DATE: November 06, 2025

PROJECT: FMAA QTA
Fort McMurrayREASON FOR ADDENDUM:
Response to RFIsISSUED BY: Rick Lin

End of Addendum E01

**AIRPORT RENTAL
CAR QTA FACILITY**

E100

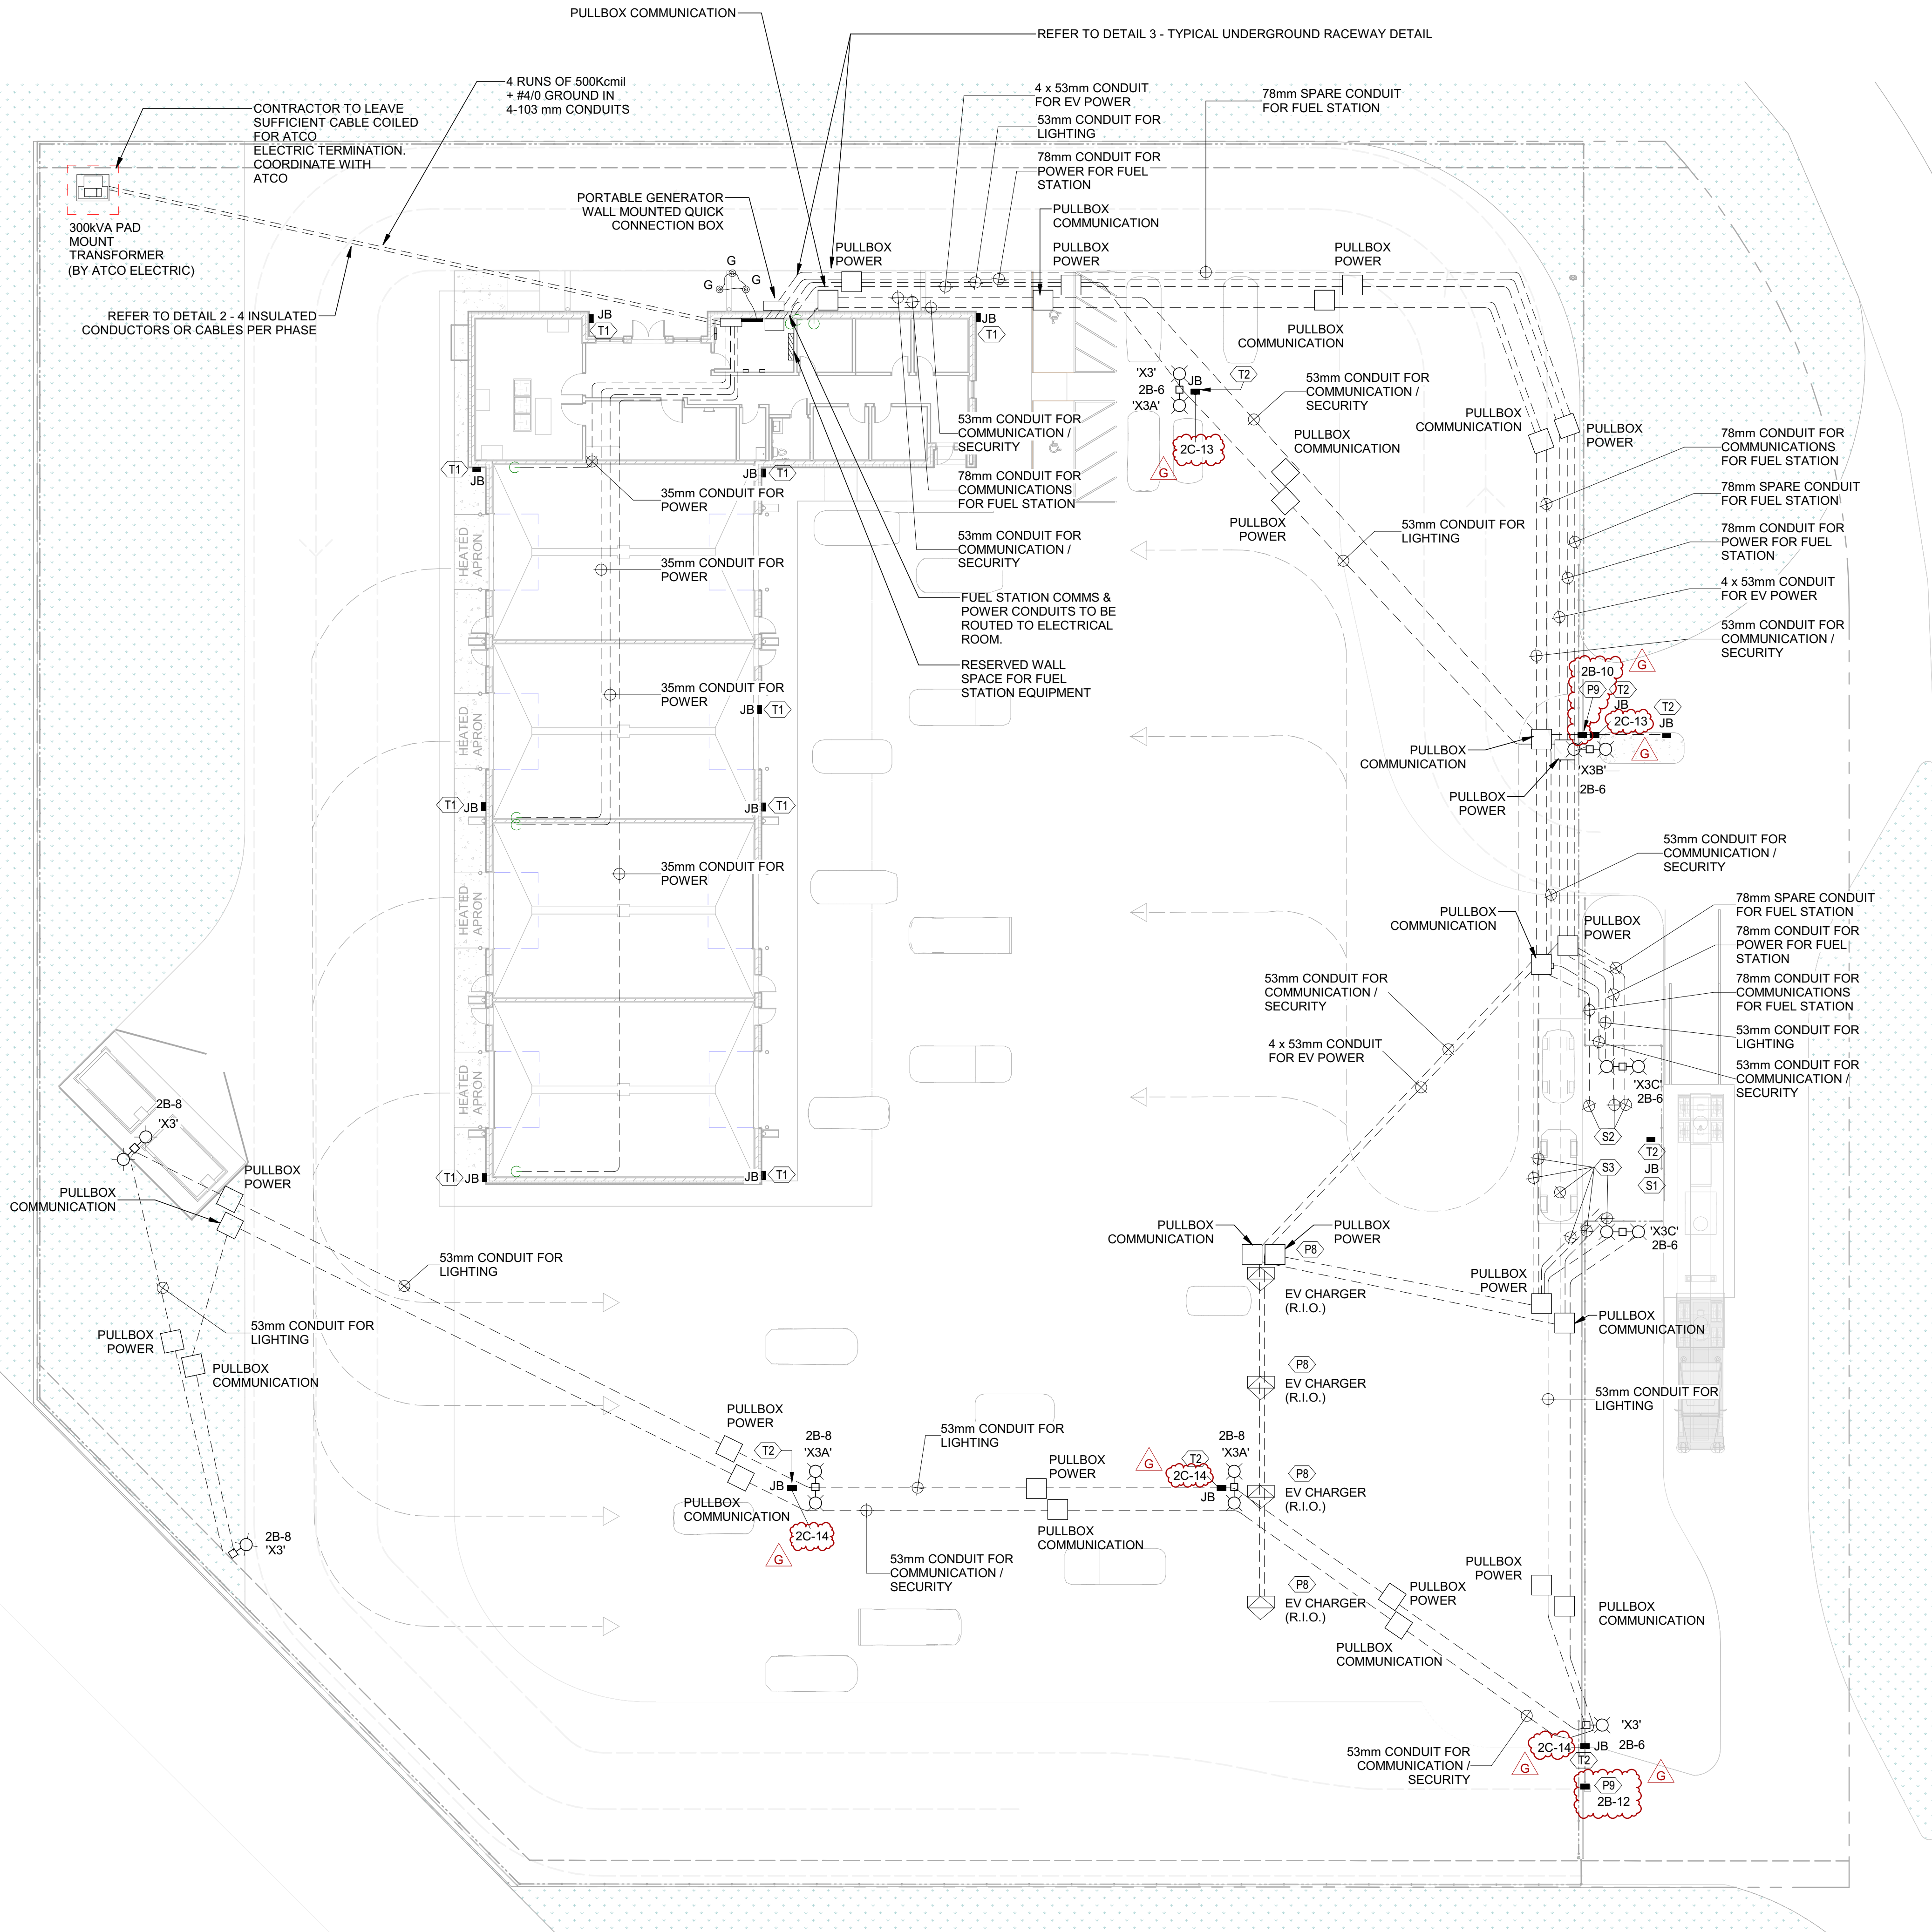
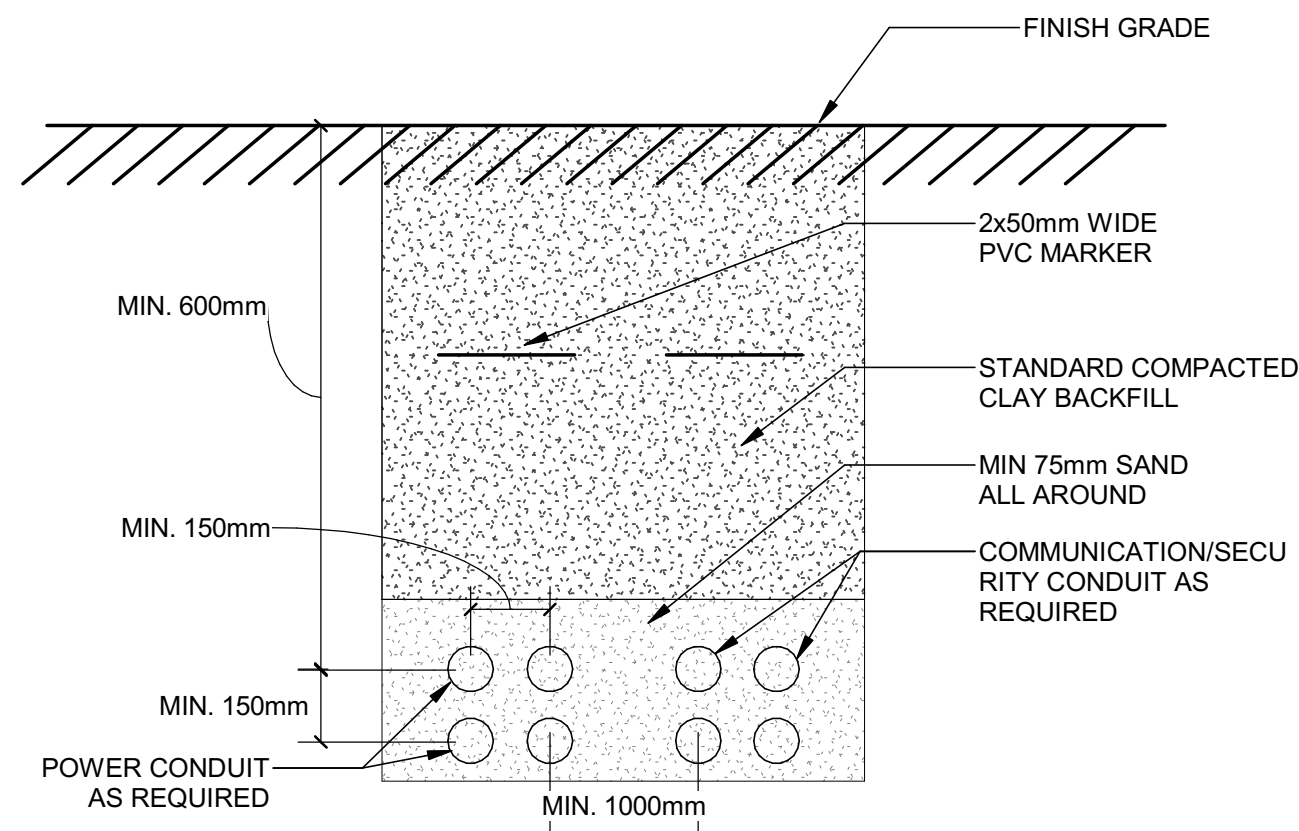
- 2.1 **ADD** separate circuits 2C-13 and 2C-14 to security cabinet on light pole.
- 2.2 **ADD** 120V power provision circuit 2B-10 and 2B-12 with associated new keynote P9 to entry and exit motorized gate.

- P9 PROVIDE 120V POWER CONNECTION TO MOTORIZED GATE.
- S1 PROVIDE 27mm CONDUIT FOR INTERCONNECTION OF EMERGENCY FUEL SHUT OFF FOR FUEL STATION. EXACT REQUIREMENT AND CONDUIT ROUTING TO BE COORDINATED ON SITE.
